Subject: RATTLE NOISE FROM AUDIO SYSTEM WHEN DRIVING	Bulletin No: 09-038/09
	Last Issued: 07/22/2009

2006-2008 MX-5

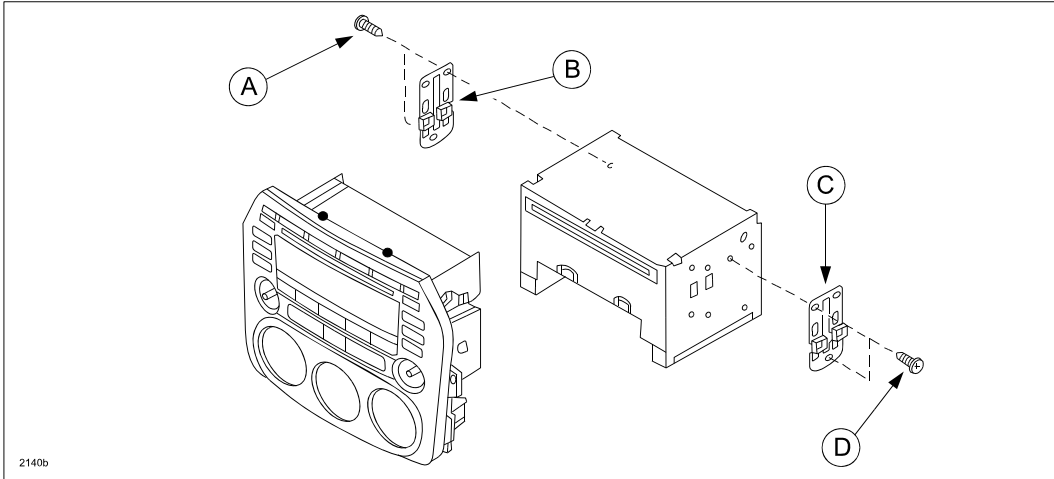
Some vehicles may exhibit a rattle noise from the audio system when driving the vehicle. Vibration from the audio brackets generate the rattle noise. The audio brackets have been modified to eliminate the noise.

1. Verify customer concern.
2. Remove center panel according to MS3 online instructions or Workshop Manual (section 09-20 CENTER PANEL UNIT REMOVAL/INSTALLATION).
3. Separate center panel and audio unit according to MS3 online instructions or Workshop Manual (section 09-20 CENTER PANEL UNIT DISASSEMBLY/ASSEMBLY).
4. Reinstall using new audio brackets (B and C) and screws (A and D) in reverse order of removal.
